AGENDA

The Columbia Architectural Design Review Team will meet on Tuesday, June 7th, 2022 at 8:00 a.m. in Conference Room A on the basement level of City Hall, 700 N. Garden Street to consider the following:

8:10 AM 22-0119 - 2008 Main Street - Modify Façade Of Existing Building
Request from Richard Thompson on behalf of Ritco Group, Inc for façade
modifications at [2008 S. MAIN STREET.](#)

PROPOSED NORTH BUILDING ELEVATION
SCALE: FIT TO SHEET

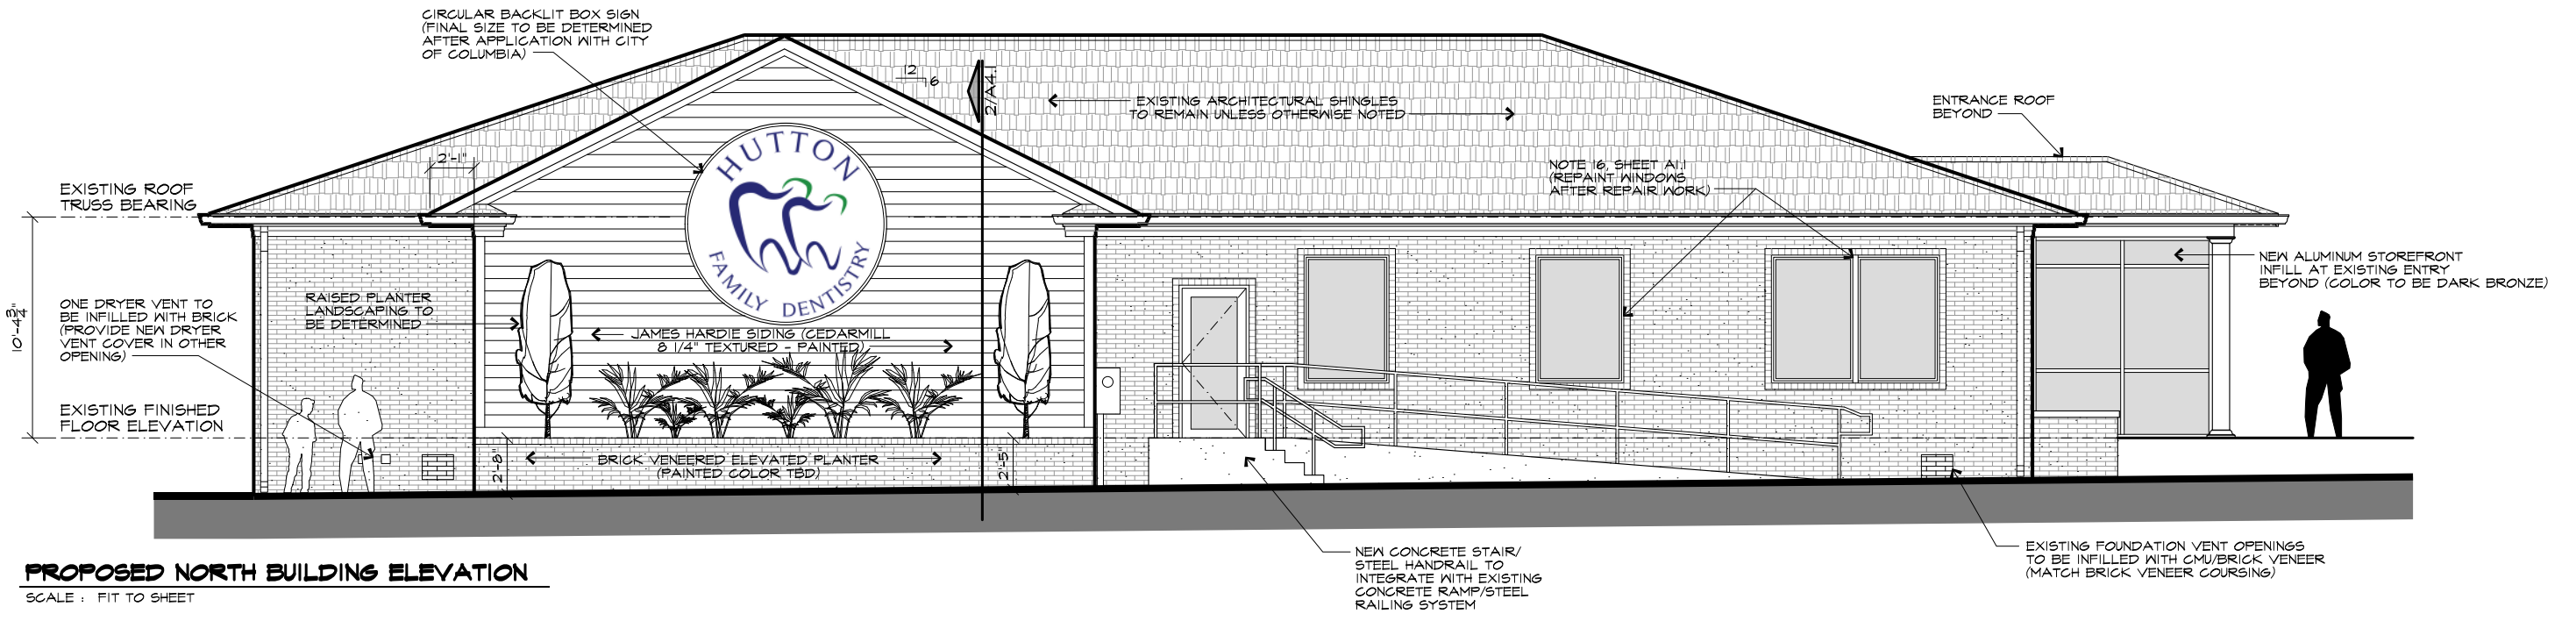
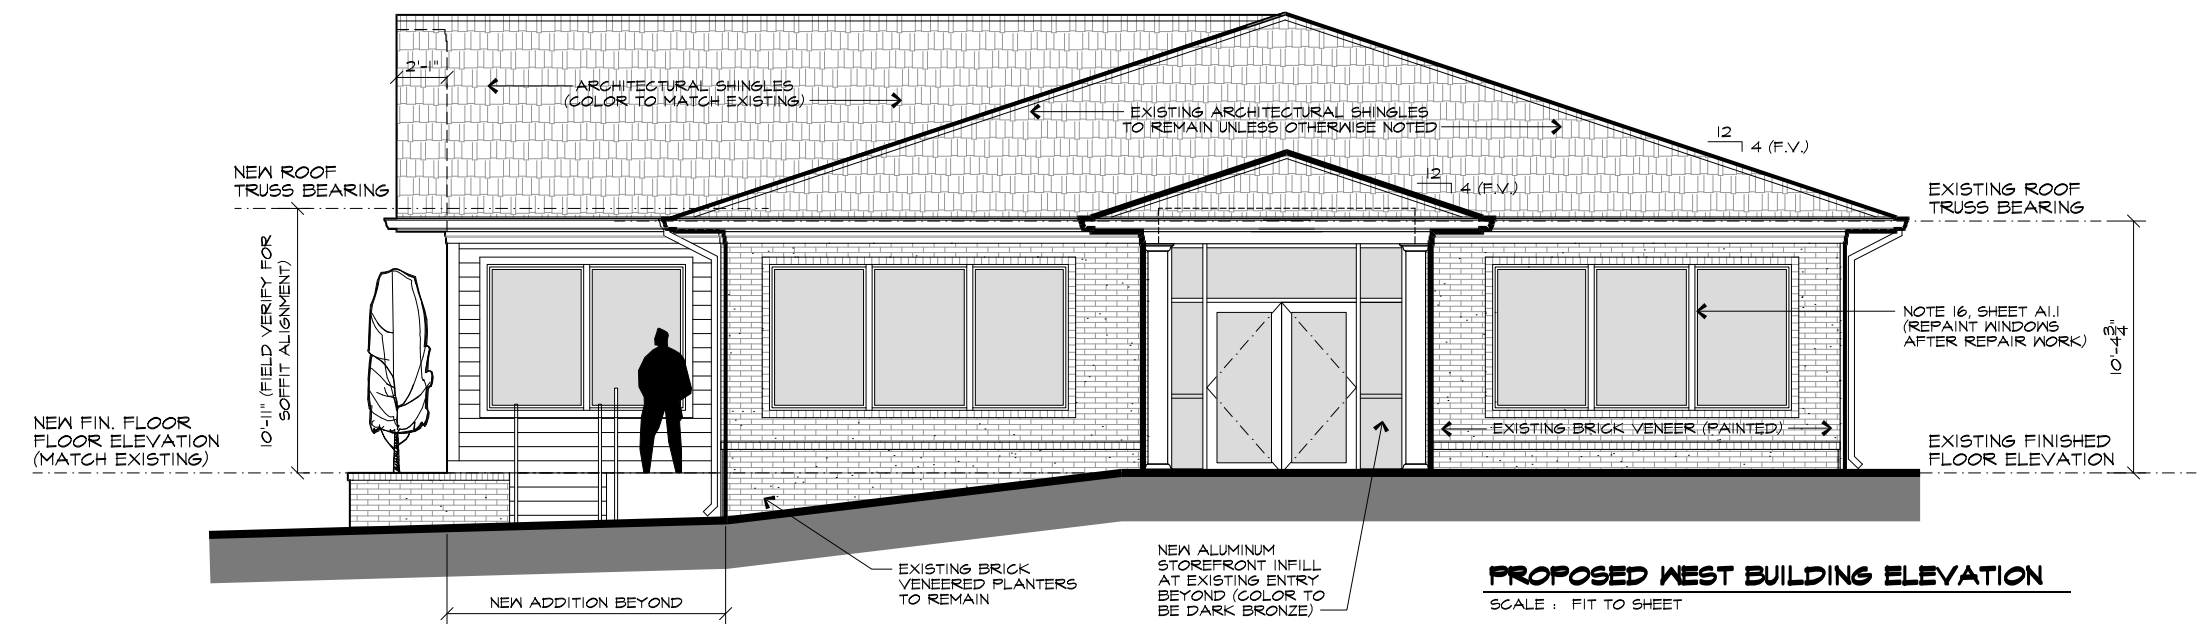
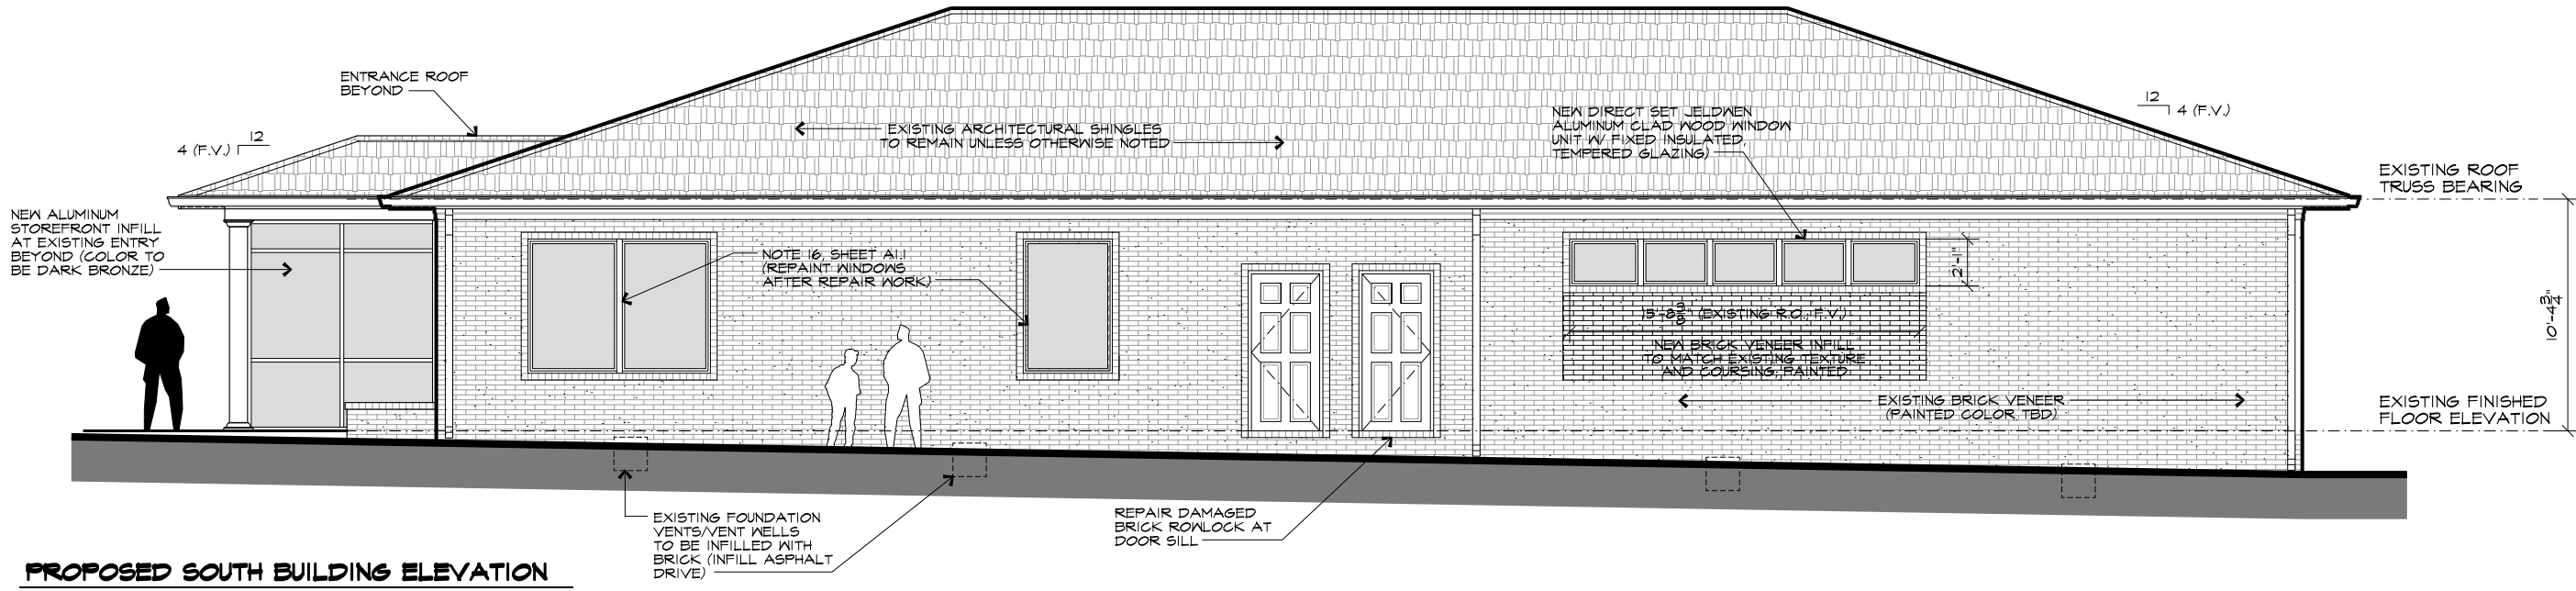
- The proposed west (front) building elevation will consist of new aluminum storefront infill with existing brick veneer to remain. A new addition will consist of a primary façade material of fiber cement board with a continuation of a hipped roof and matching architectural shingles. As noted, fiber cement board is an appropriate material per the design standards referenced.
- The east and south elevations consist of existing brick with new aluminum wood clad window openings.
